Service Bulletin

No. : MZ09-100 **Date:** September 30, 2009

Model: SR6004, SR5004

Subject: A Hum Noise occurs at shorting of FRONT AUX Audio input.

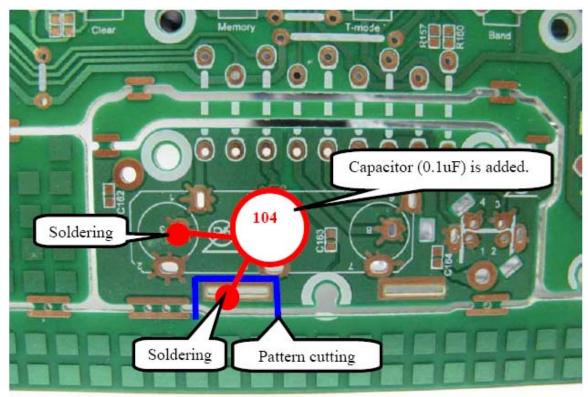
Symptom: The AUX Audio input (Front) terminal is shorted at MAIN Volume MAX. The Hum noise is louder than REAR AUX input terminal in the rear panel. The earth side of the AUX input terminal is connected directly with the chassis, the earth circuit is looped.

Solution: Add a capacitor and cut the trace as outlined.

Bottom SIDE of CUP12205Z/Y AUX P.W.B. (FRONT P.W.B. ASSY)

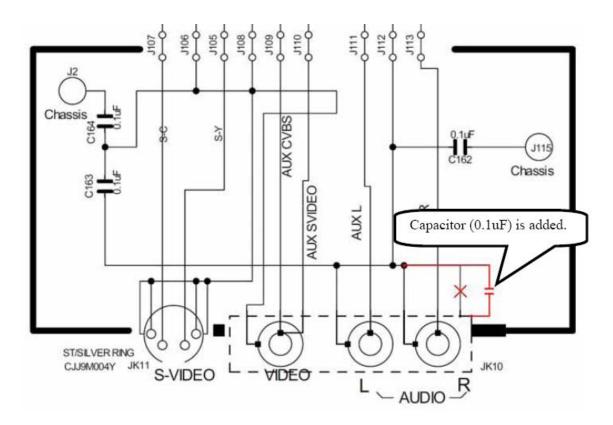
Before the modification:

Please add the following capacitor on AUX P.W.B. (FRONT P.W.B. ASSY: CUP12205Z/Y) and cut the pattern as shown below.

Ref. Nr.	Parts Number	Parts Name	Remarks
-	nsp	CCBS1H104ZFT	0.1uF+80/-20% /50V CERAMIC Capacitor CCBS1H104ZFT
